Access Compliance Report

Public Rights-of-Way (Curb Ramps)

Intersection ID: 42409	Main Street: NEWFANE_RD	Cross Street: SACKETT_WY	Location: S
ADA ID: 1504F766C5B1	Ramp Type: Perp	Initial Pass/Fail: Fail	Overall Compliance: No
			Severity Score: 21.25

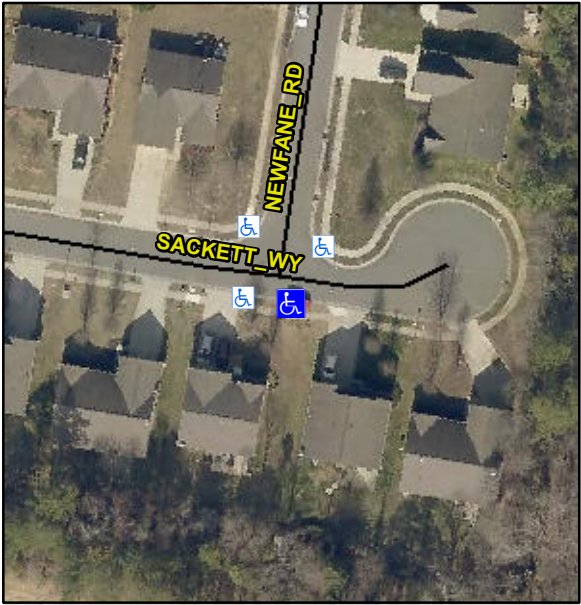
Codes/Mitigation Info/Possible Solution			Field Measurements/Component Compliance		
	Possible Solutions:		Compliance	Description	Data
	Remove & Replace Entire Ramp.		No	Ramp Length (in)	47.0
			No	Ramp Width (in)	46.0
			N/A	Flare Type LT	N/A
			N/A	Flare Slope LT (%)	N/A
			N/A	Flare Traversable LT?	N/A
			N/A	Landing Length (in)	N/A
			N/A	Landing Width (in)	N/A
			N/A	Landing Slope (%)	N/A
			N/A	Landing X Slope (%)	N/A
<p>Surveyor Notes:</p> <p>N/A</p> <p>PROW/ADA:</p> <p>Not Found, R304.5.1, R304.2.2</p>			N/A	Flare Type RT	N/A
			N/A	Flare Slope RT (%)	N/A
			N/A	Flare Traversable RT?	N/A
			N/A	DWS Provided?	N/A
			N/A	DWS Contrast?	N/A
			N/A	DWS Length (in)	N/A
			N/A	DWS Full Width?	N/A
			N/A	DWS Offset (in)	N/A
			N/A	Gutter Ponding?	N/A
			N/A	Gutter Lip Ht (in)	N/A
			No	Painted X Walk1?	N/A
				X Walk 1 Direction	To NE
			N/A	X Walk 1 Width (in)	N/A
				X Walk 1 Slope (%)	3.1
				X Walk 1 X Slope (%)	2.1

N/A	Ramp inside XWalk1?	N/A
			N/A	Road Slope (%)	N/A
			N/A	Road X Slope (%)	N/A
			N/A	Any Obstructions?	N/A
				Obstruction Type	
Total Cost:					N/A
		\$ 1850.00			N/A
			Yes	Surface Condition? (G/P)	Good
